ADDENDUM NUMBER 1

FRANKLIN LANDFILL
INFRASTRUCTURE UPGRADE
76th Street and Rawson Avenue
Franklin, WI

Project Number: V022-15803

Date of Addendum: November 5, 2015

PROJECT TITLE:	EASTERN INFRASTRUCTURE UPDATE
SHEET DESCRIPTION:	HEADER PLAN AND PROFILE (Revised 11/5/15)
SITE NO.	
BUILDING NO.

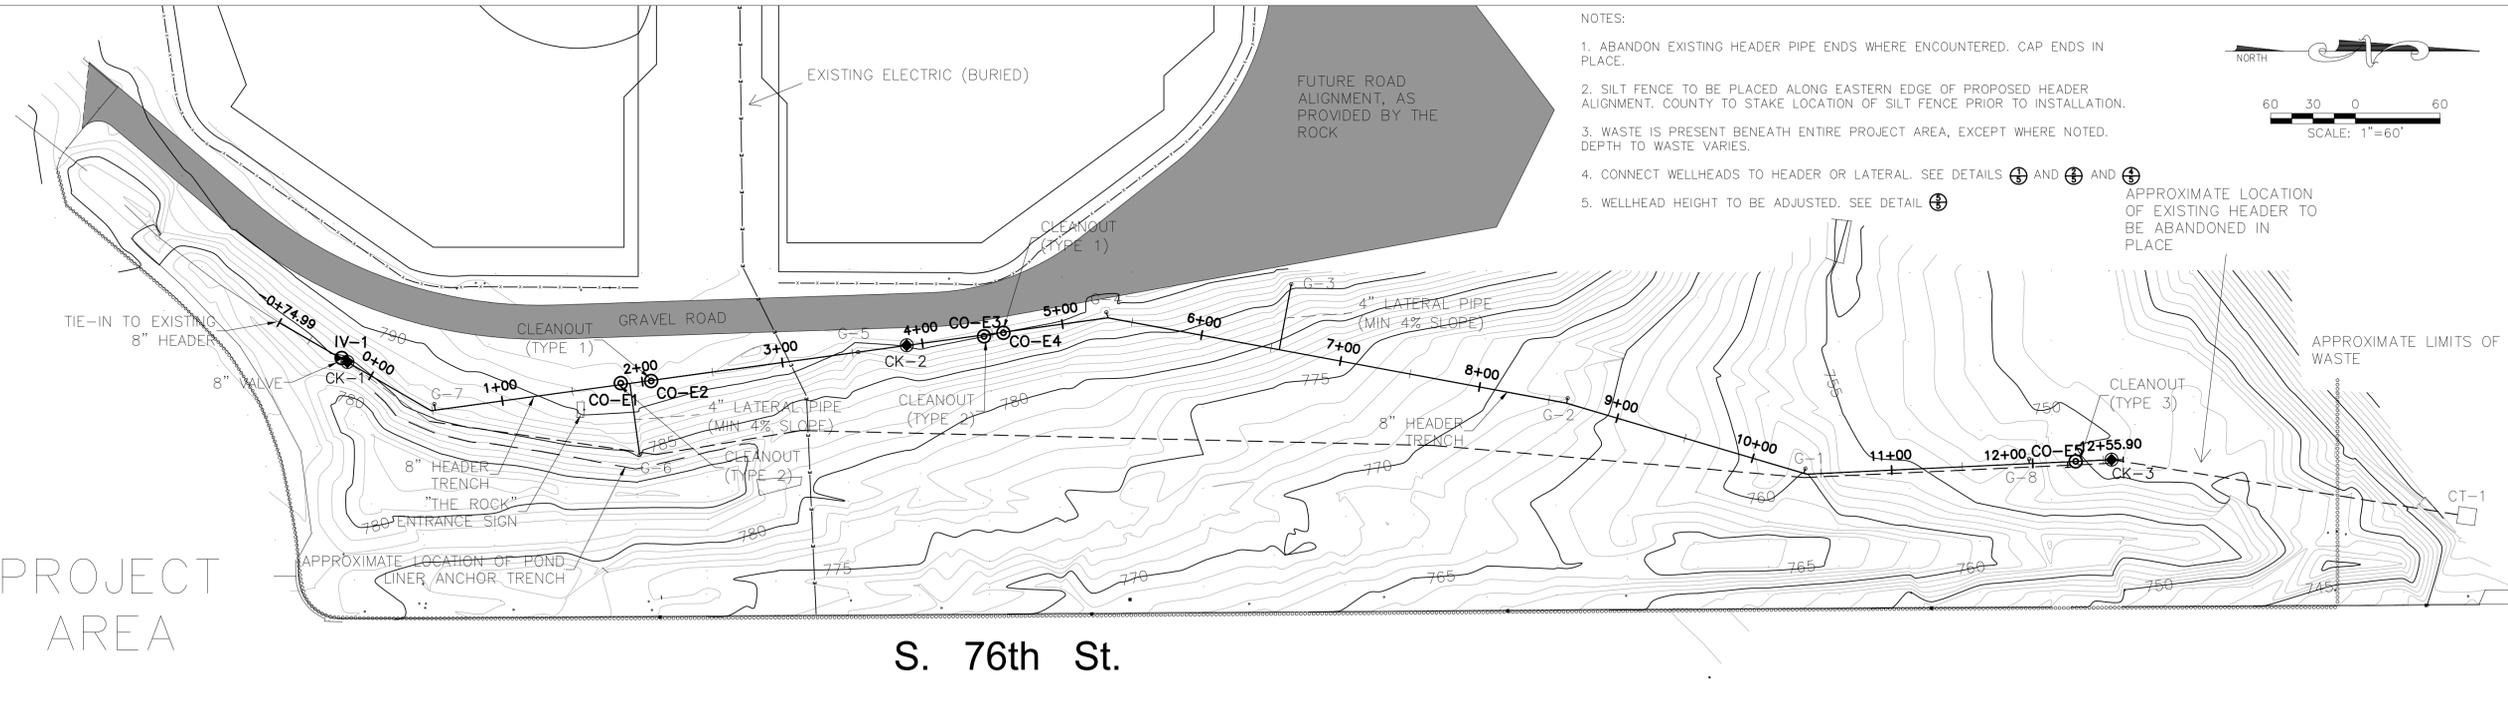
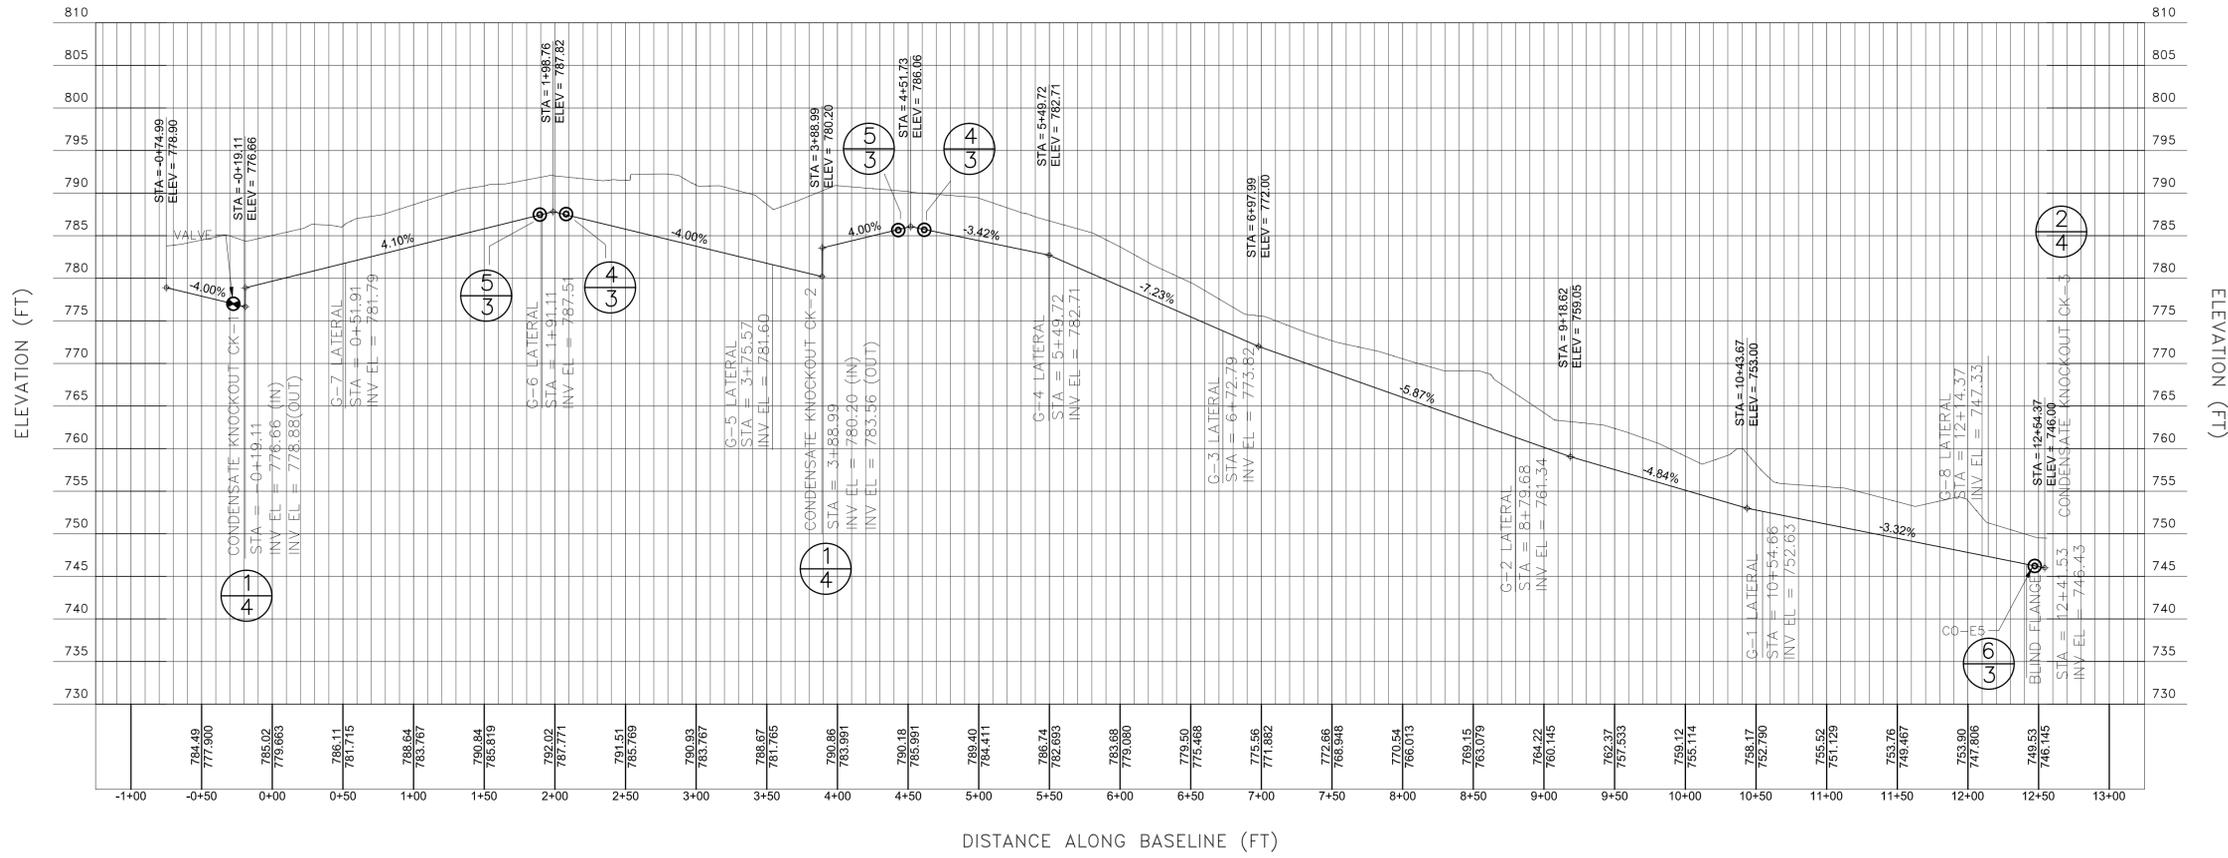
Sheet 2: Add the following to Notes:

6. The volume of CT-1 is assumed to be 500 gal and will be pumped out by Milwaukee County prior to scheduled removal. Tank can be rinsed clean on site prior to off site disposal.
7. The contractor shall restore the disturbed area from station 0+00 thru 2+00 with WisDOT No. 40 seed mix. All other disturbed areas on the east and west sides shall be restored using WisDOT No. 20 seed mix.
